HIGHLAND CITY DEVELOPMENT ADMINISTRATION BOARD AGENDA

DEVELOPMENT ADMINISTRATION BOARD AGENDA REPORT ITEM #2

DATE: April 11, 2024
TO: Development Administration Board
FROM: Rob Patterson, City Attorney / Planning & Zoning Administrator
SUBJECT: **Final Plat Approval:** Foxwood Estates
TYPE: **LAND USE (ADMINISTRATIVE)**

Foxwood Estates Subdivision

Sheet No.
P - 14

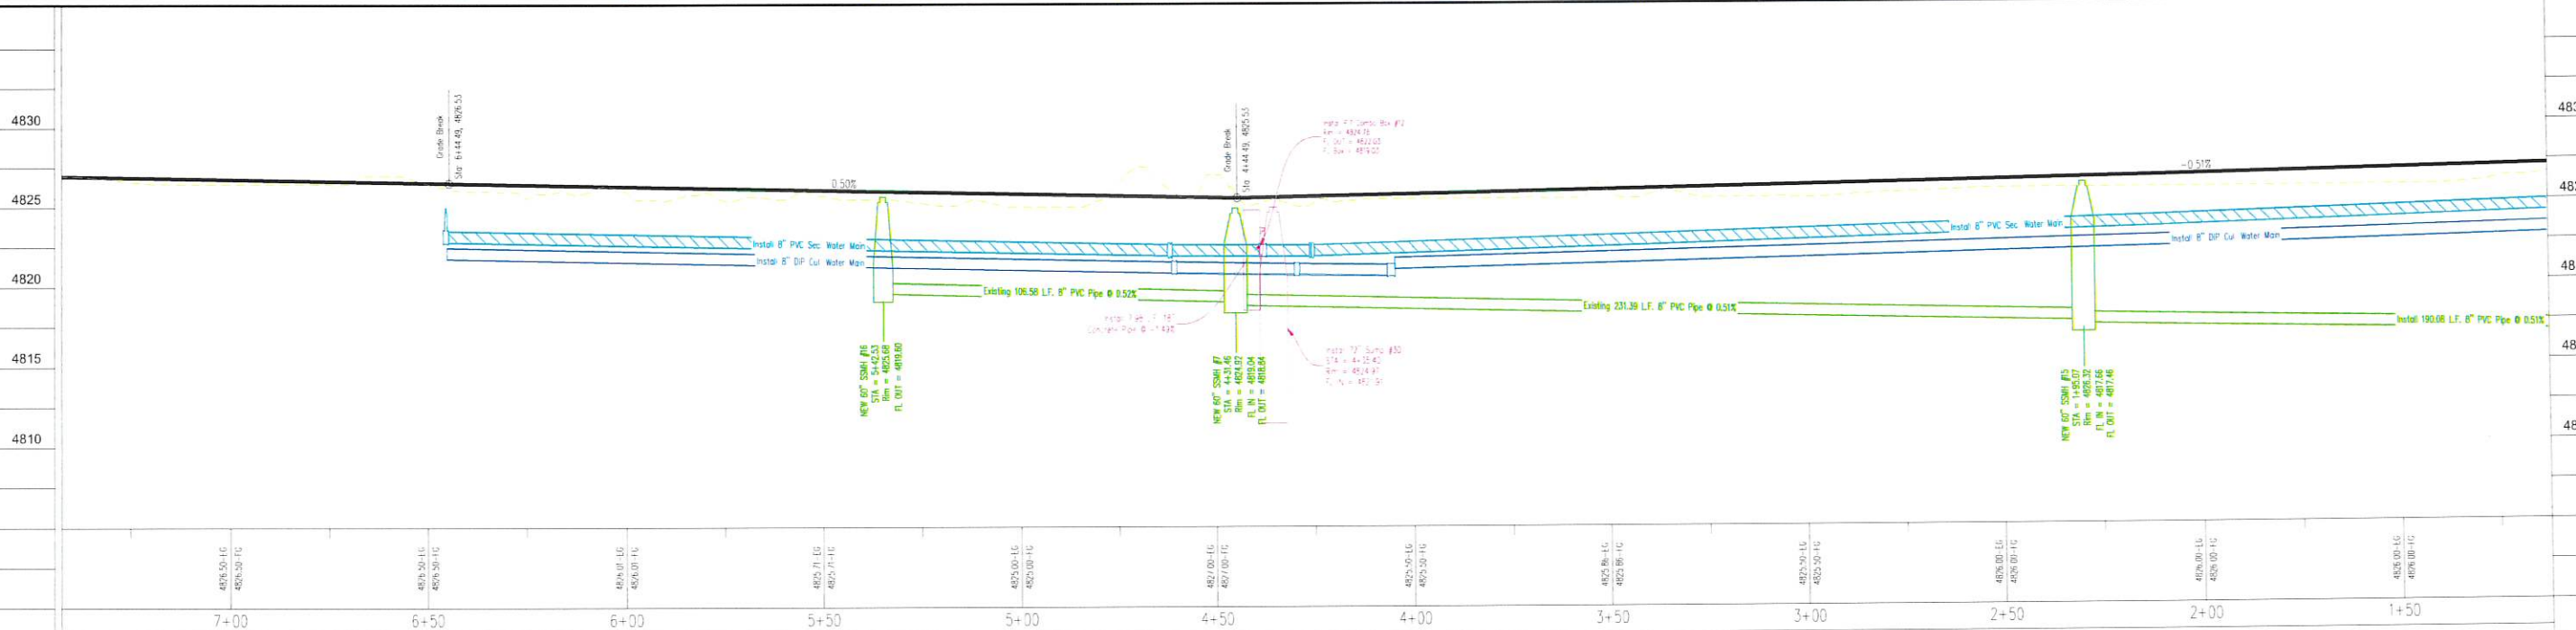
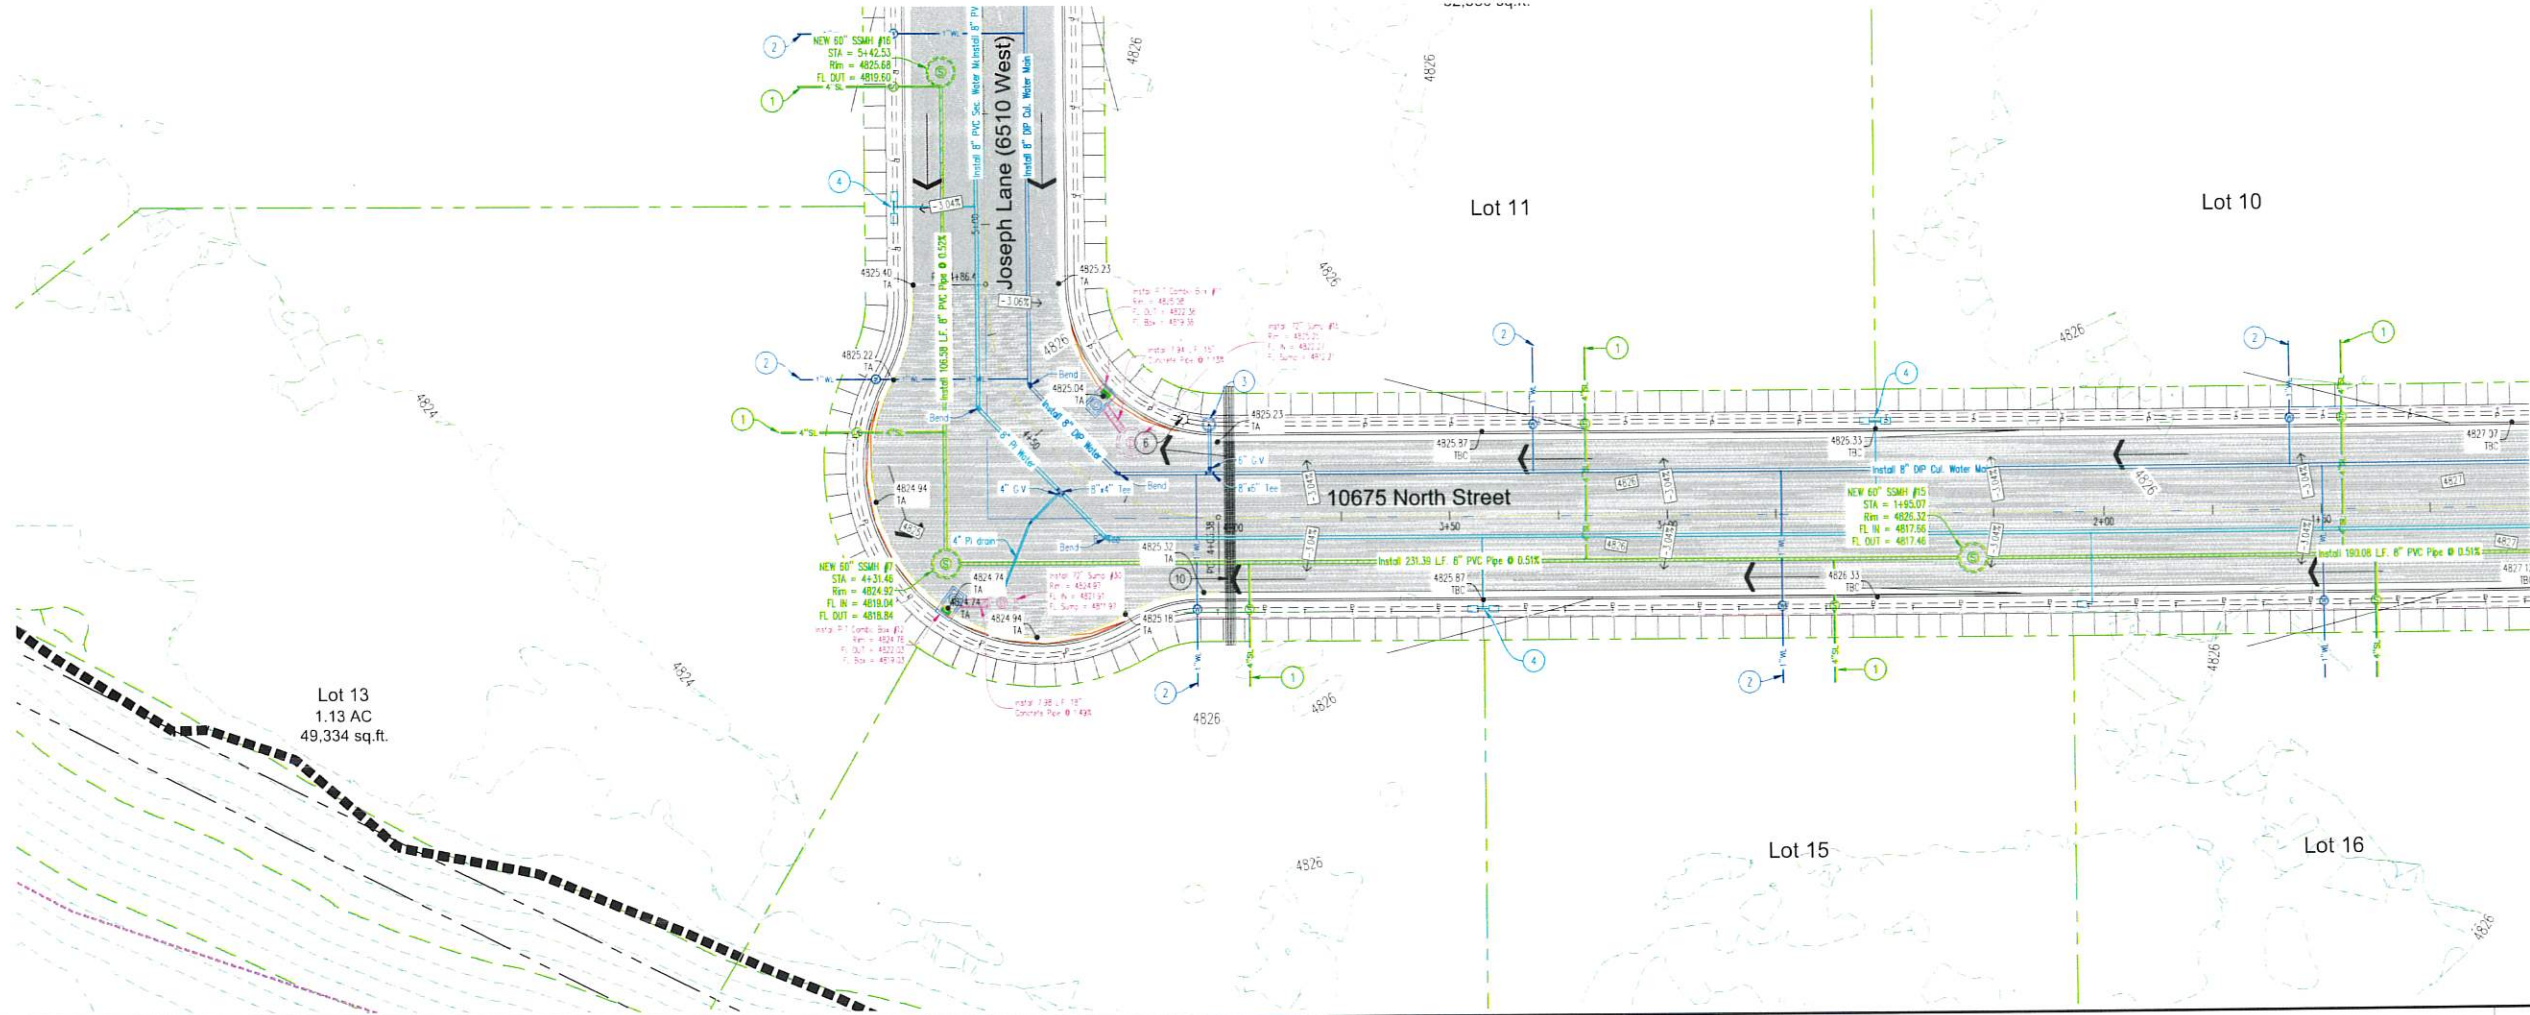
Sheet P-14:

Sheet No.
C - 16

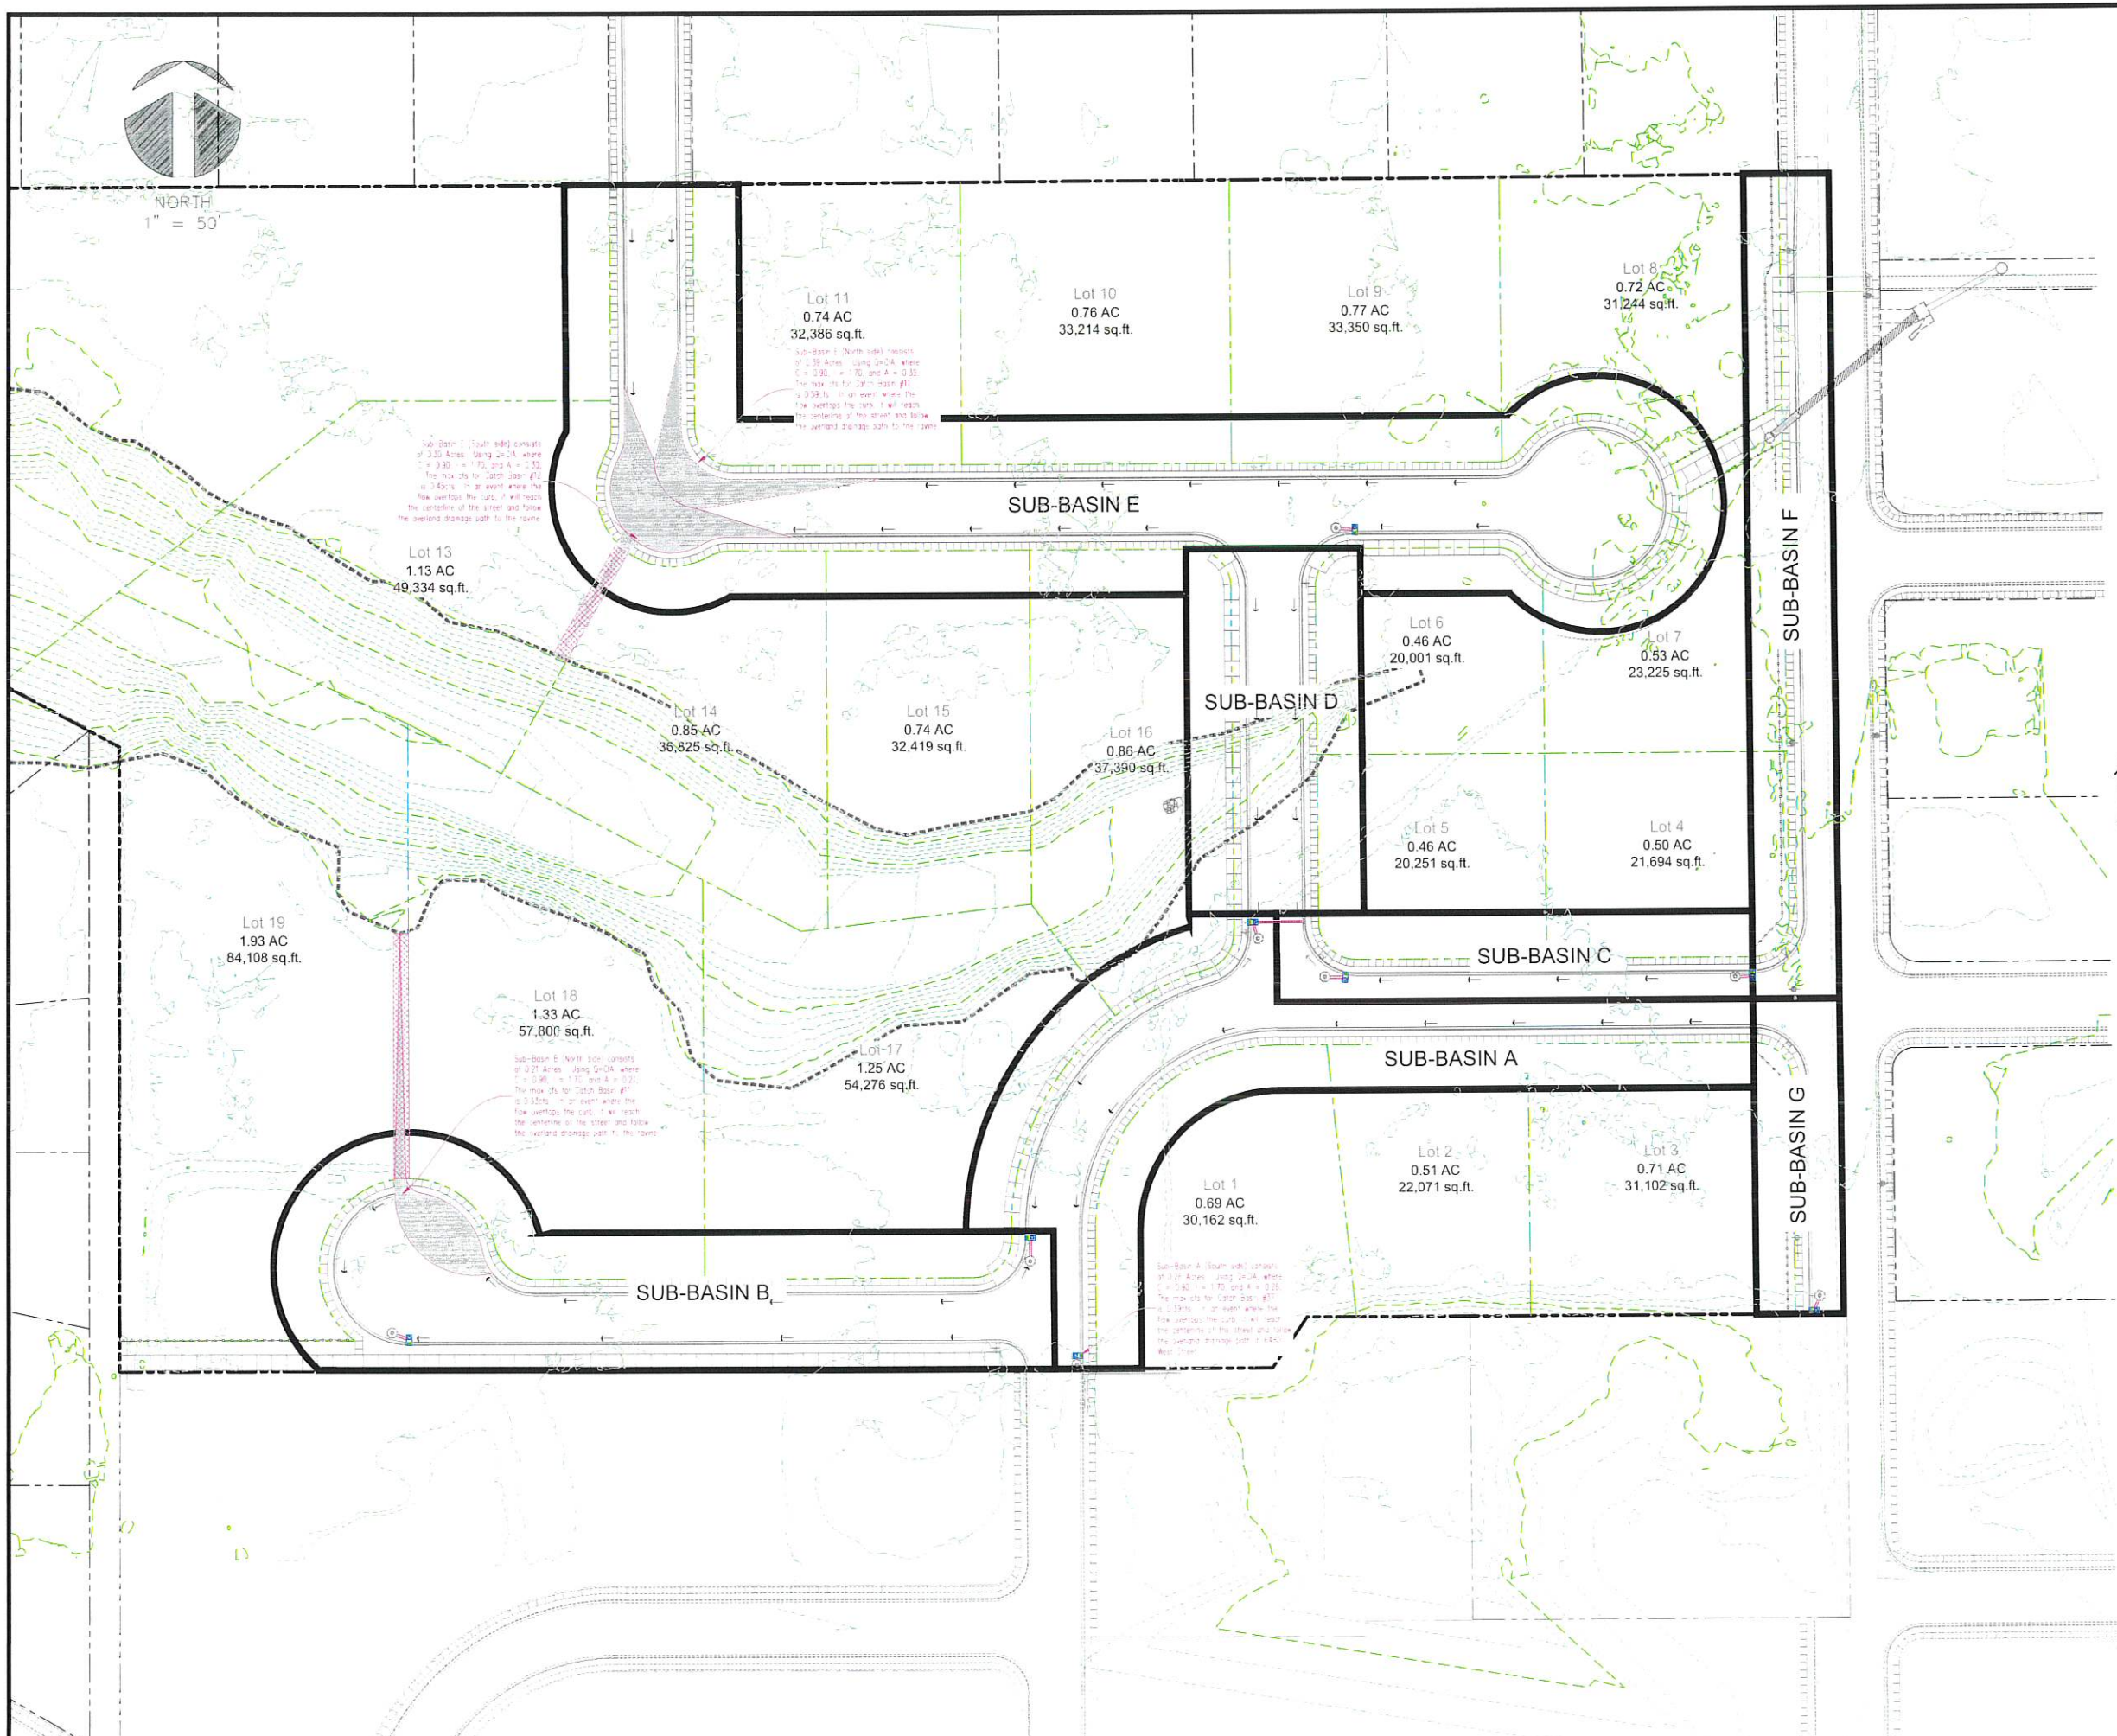
Sheet C-16:
